**Champlain Hudson Power Express ("CHPE")
Environmental Management & Construction Plan
Notice of Major Change**

Project: Champlain Hudson Power Express

Segment: 12

Notice Number: 054

PERMIT DRAWING NO. **N/A**
DRAWING NO. **G-007**

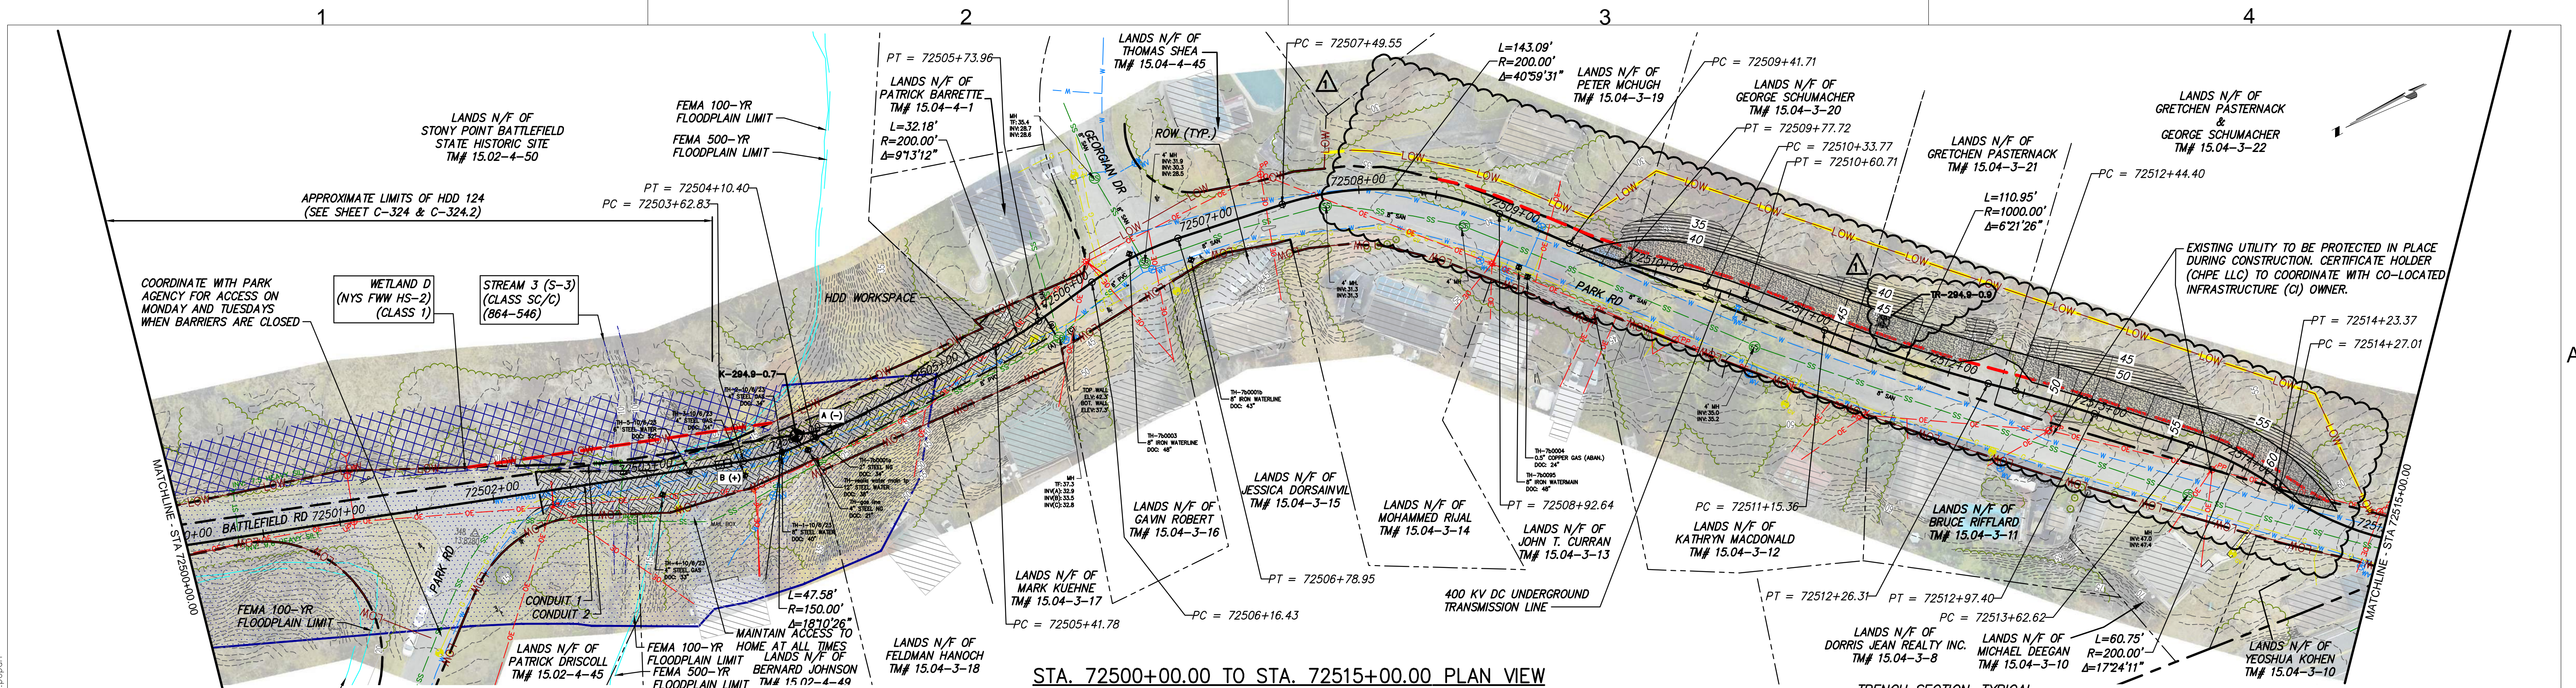
- As part of project wide cable length optimization, link boxes inside splice vaults have been revised (Shts. G-007, C-106 & C-107).
- Due to change in alignment as noted above, "Station Equations" have been added to the alignment stationing to minimize revising plan sheets not impacted by any changes (Shts. C-102, C-104 & C-108).

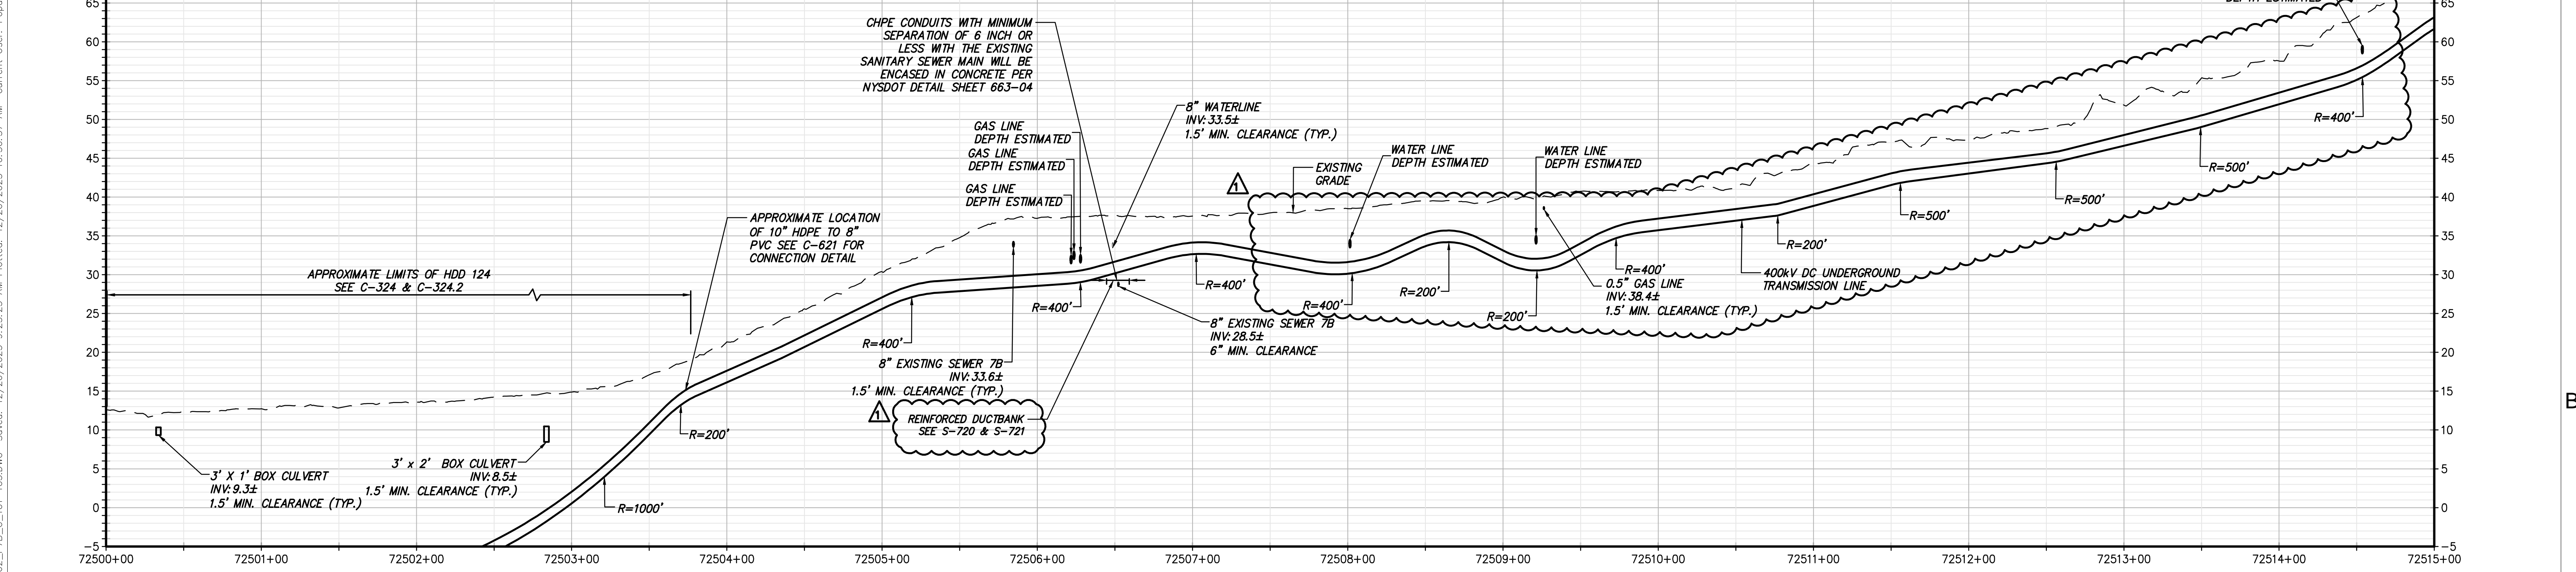
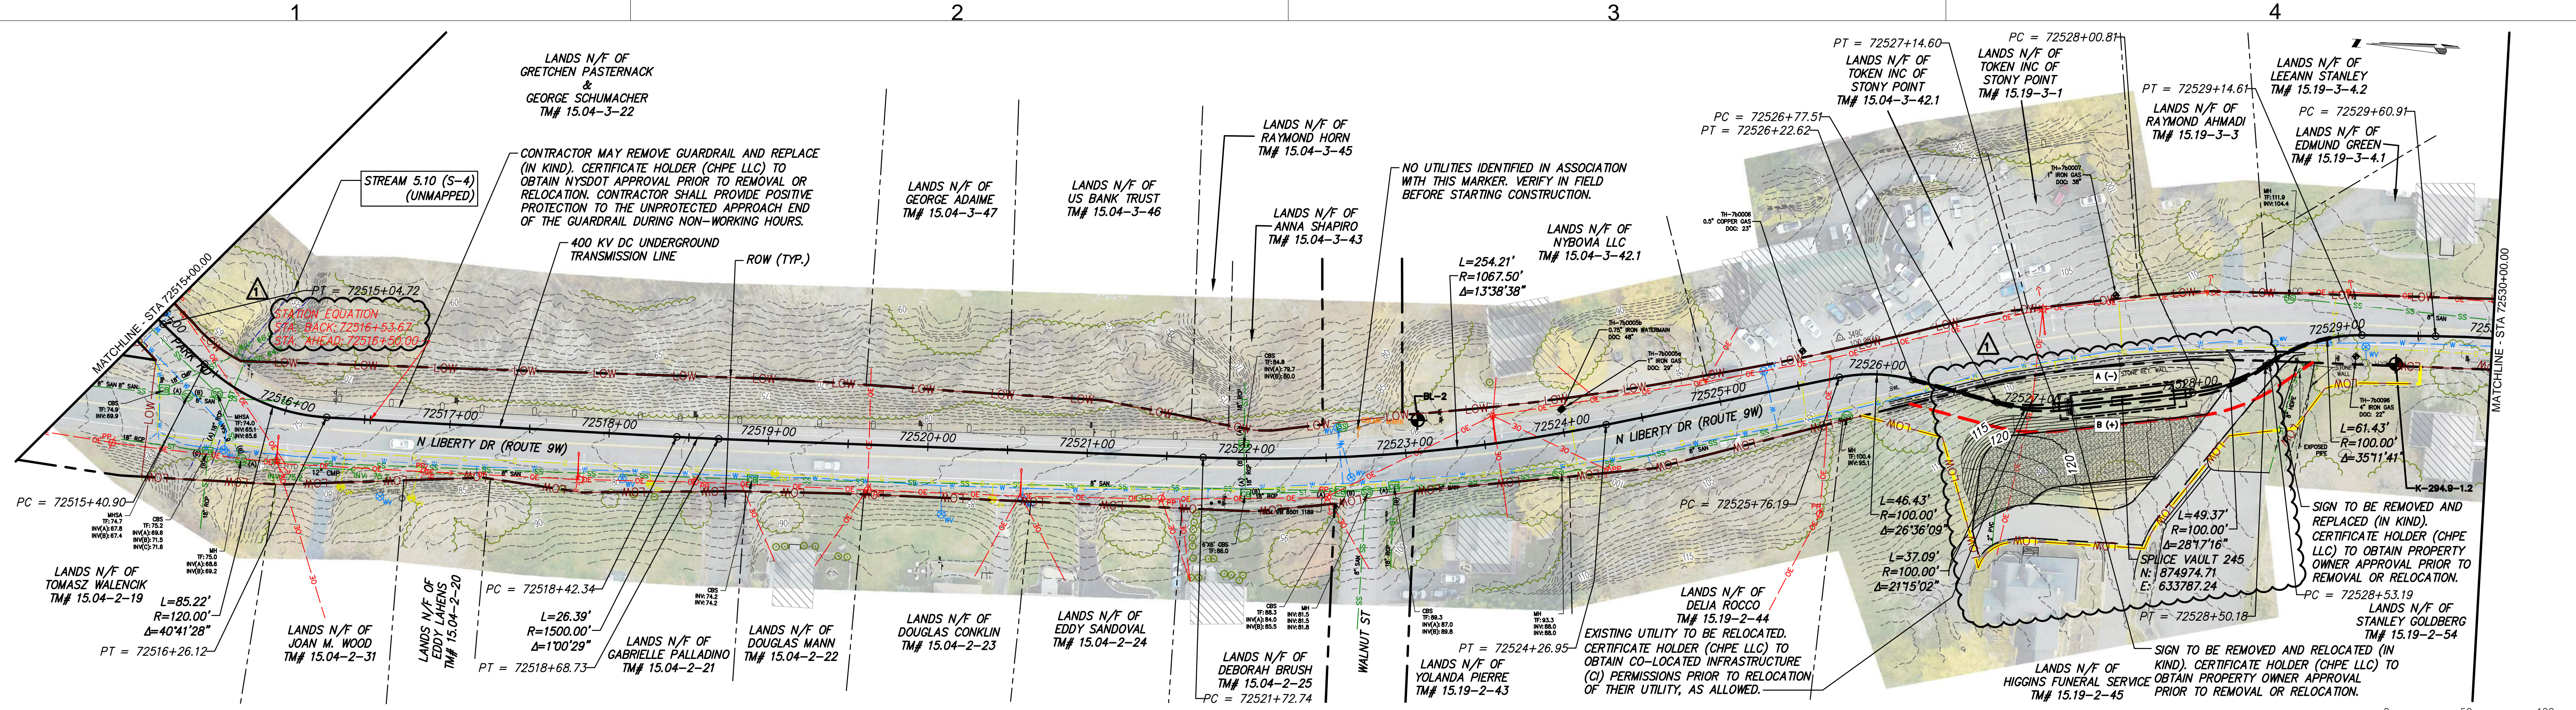
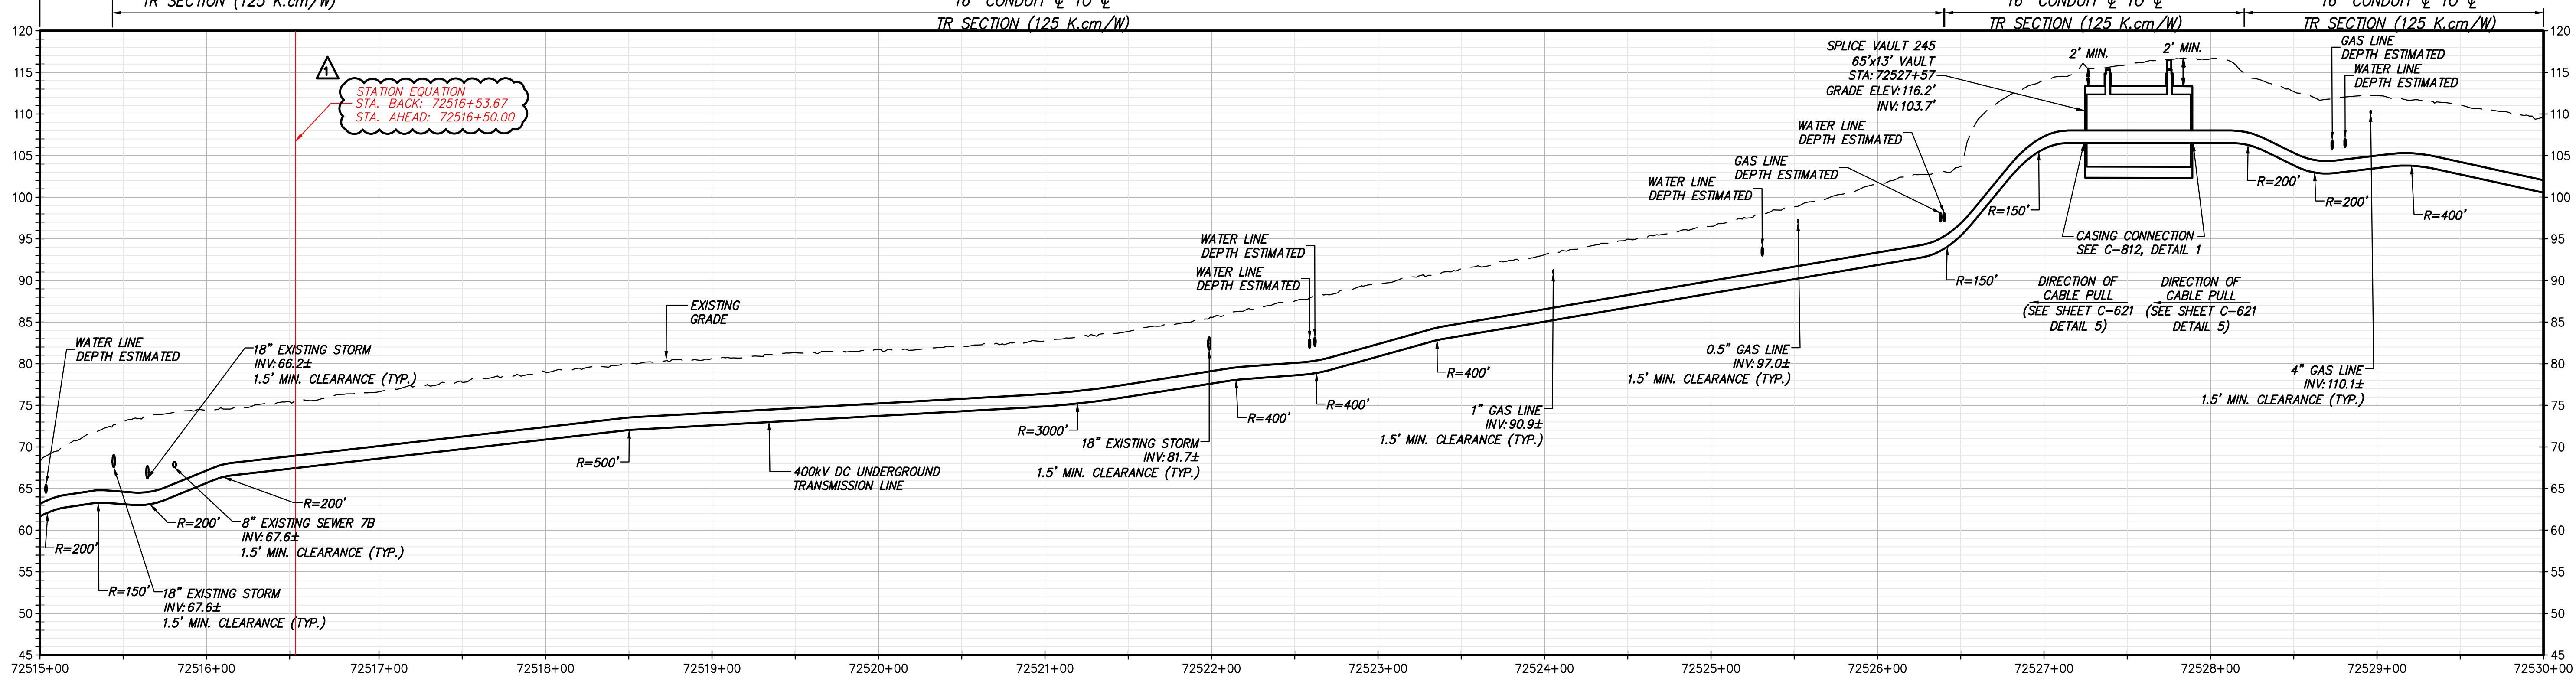
B. Realignment to avoid Veolia water main along Park Road: A recently installed 8-inch water main in Fall of 2023 by Veolia has necessitated shifting CHPE alignment along Park Road from ~Sta. 72507+50 to ~sta. 72514+50 to avoid any utility conflict. This change has affected four adjacent privately owned properties (Peter McHugh TM# 15.04-3-19, George Schumacher TM# 15.04-3-20, Gretchen Pasternack TM# 15.04-3-21, and Gretchen Pasternack TM# 15.04-3-22) which are now impacted by the change.

- Notes from Orange and Rockland (Gas & Electric) added to sheet G-004.
- Location of additional soil borings have been added (Shts. C-101, C-103, C-106, C-107, C-109, C-112, C-118, C-124, & C-125).

- Consistent with NYSDEP request to install reinforced ductbank over all DEP regulated stream crossings to facilitate future improvement at those facilities, similar note has been added to all drainage crossings throughout this segment (Shts. C-101, C-103, C-104, C-107, C-108, & C-115).

This change would also require adding another excursion to the Deviation Zone Table 1 of EM&CP "Appendix E Justification for Deviation Zone Excursions in Segment 12" as below:

Excursion	Parcel ID	Location (Approximate – see Drawings for Details)				Justification for Revision	Environmental Impact Reviewed
		Sheet	Mile Point	Station Start	Station End		
S12-1A	15.04-3-19	C-101	0.84	72507+80	72509+82	Realignment to avoid new water main	Cultural Resources; Recreation; Terrestrial Ecology; ESA 1
	15.04-3-20	C-101	0.91	72509+82	72511+35		
	15.04-3-21	C-101	0.93	72511+35	72512+35		
	15.04-3-22	C-101	0.98	72512+35	72514+90

PERMIT DRAWING NO. N/A
DRAWING NO. C-102

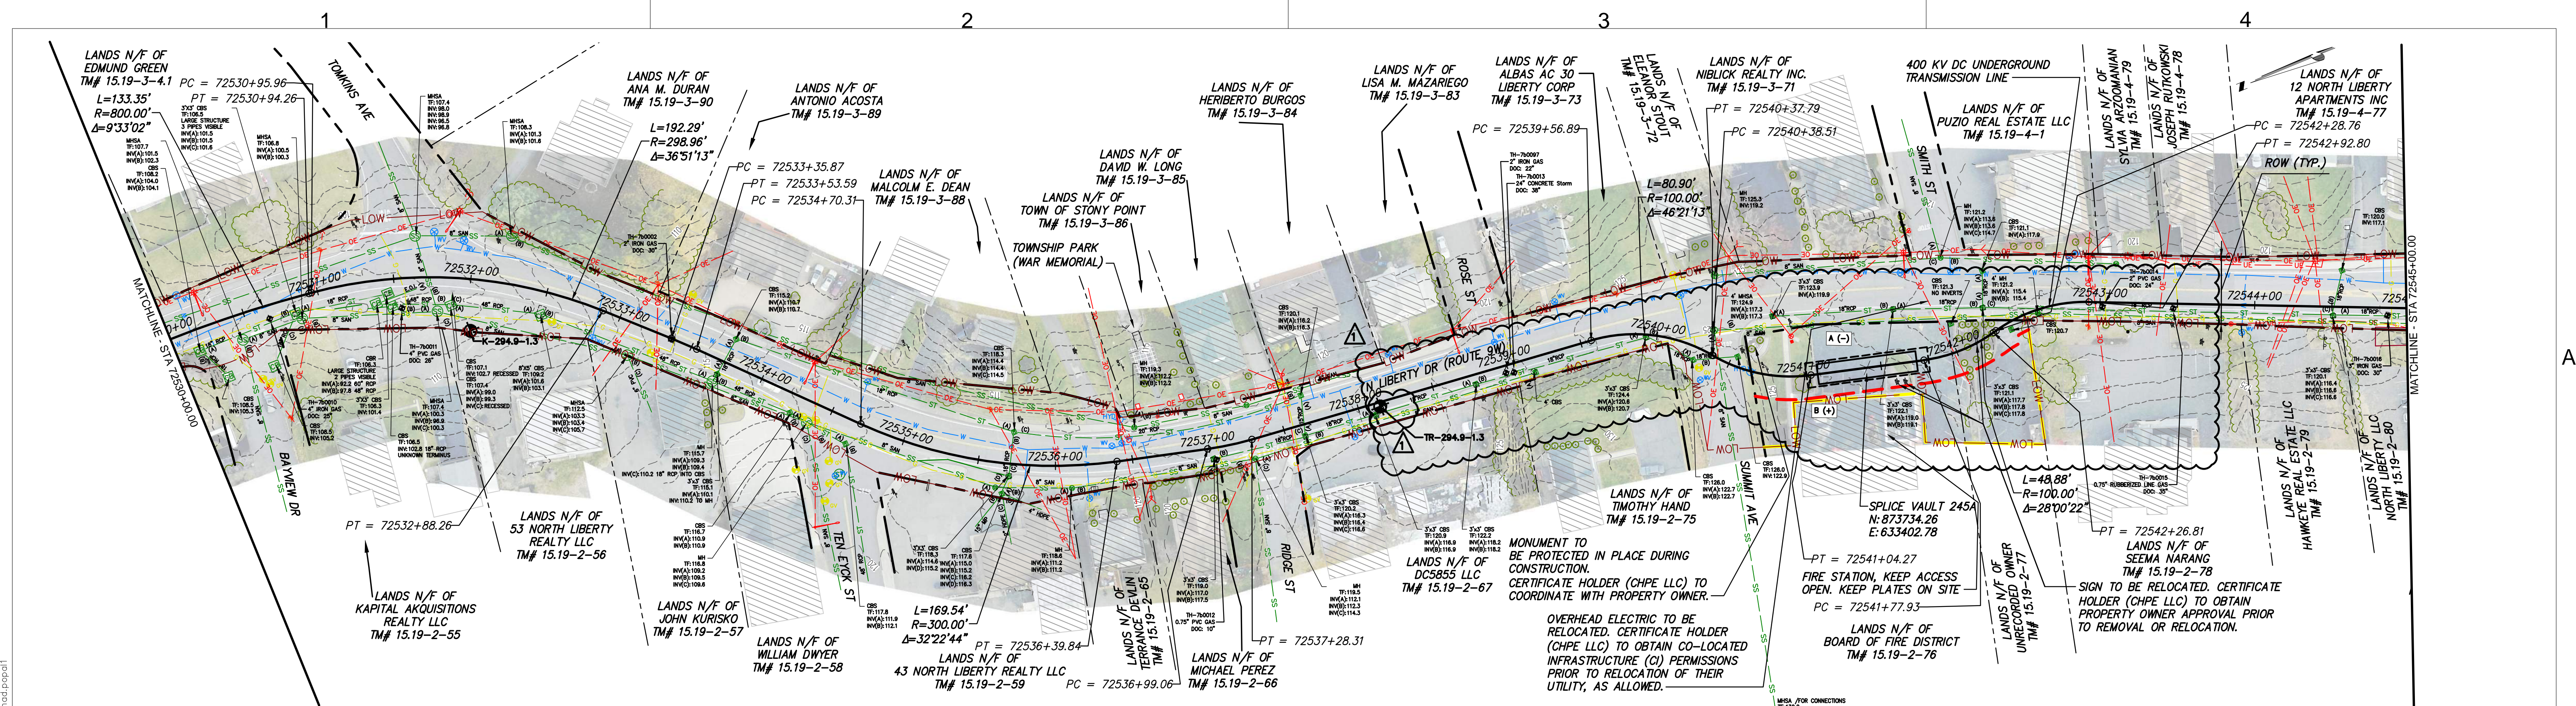
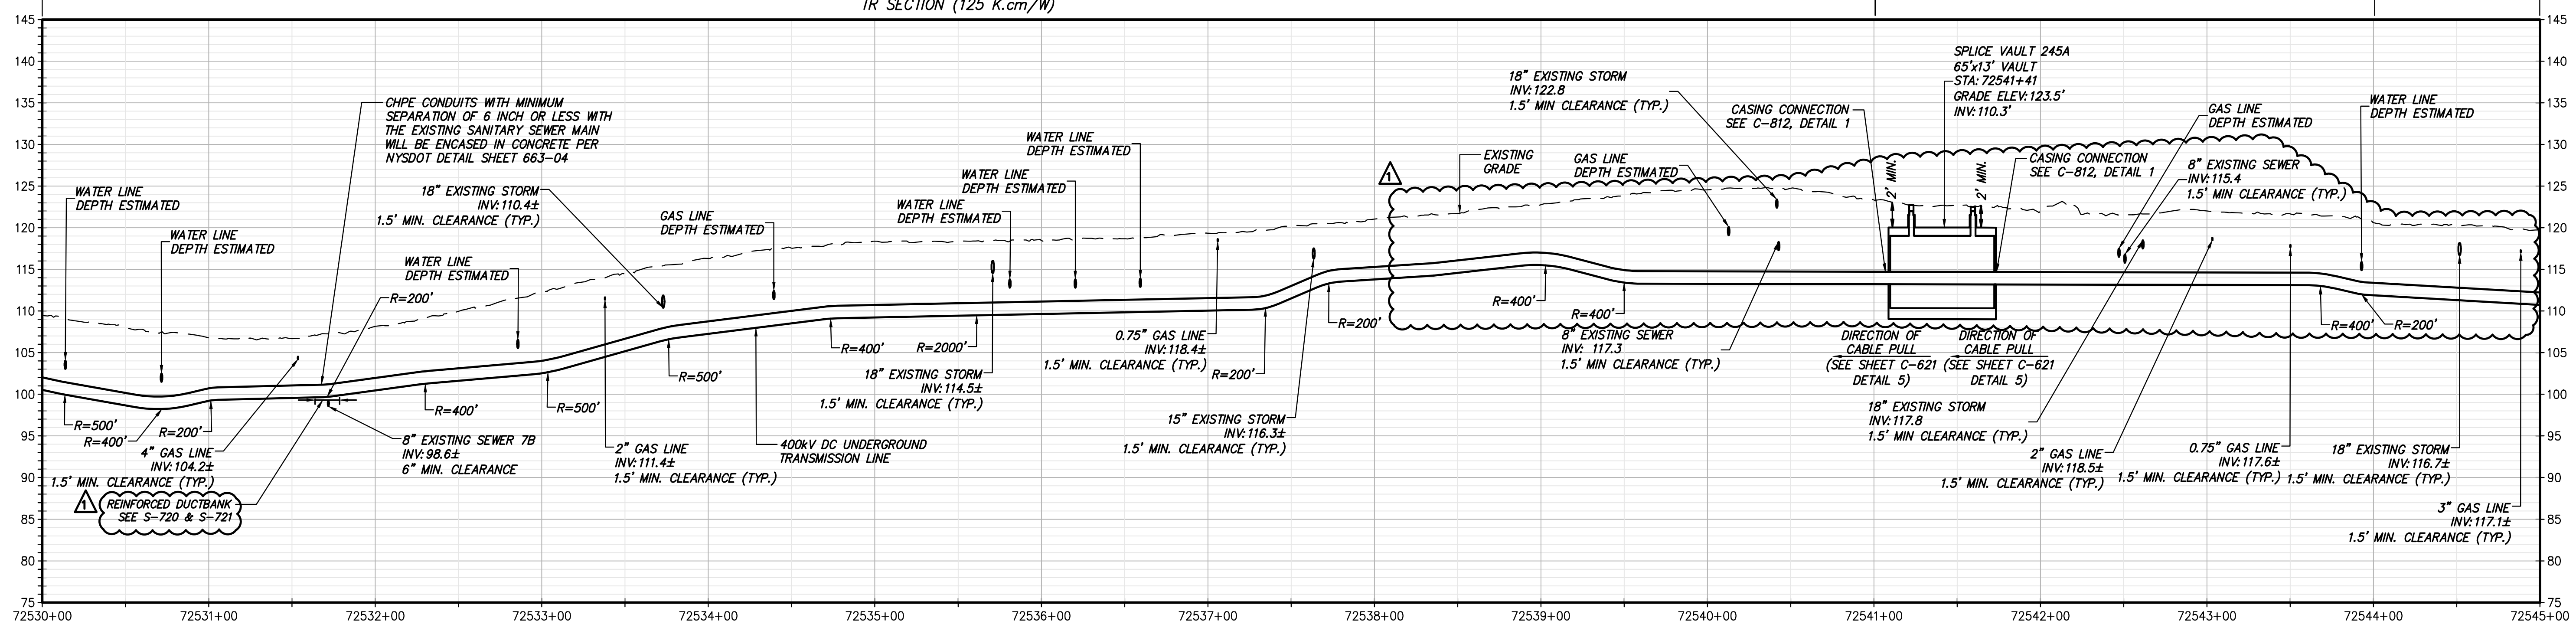
- A. Shifting of SV-245A:** This change involves a shift in the location of a vault, which results in portions of the alignment falling outside of the deviation zone in Segment 12. This change is intended to minimize impacts to an active business and maintain safety during construction. Coordination with this business owner revealed the need for additional space to ensure the business could maintain its access, parking, and other operational needs in close proximity to an active construction area, which proved to be more difficult than originally anticipated when developing the plans previously approved in the Segment 12 EM&CP. Having reviewed several alternatives with the owner of Liberty Beer (property of DC5855 LLC/; TM#15.19-2-67) to install splice vault # 245A in front of its business, it was determined that shifting the vault approximately 300ft south in front of Stony Point Fire District Wayne Hose Co. No.1 Station 1 building (property of Board of Fire District; TM# 15.19-2-76) was a more viable option. The Fire House has recently built a new garage facility for its fire trucks at the rear of the property and installing the vault at the proposed location would not impede its accessibility, operation, and emergency response. This property also offers sufficient room to install the vault without encroaching adjacent properties; and thus, minimizing disturbances to adjacent businesses and traffic.
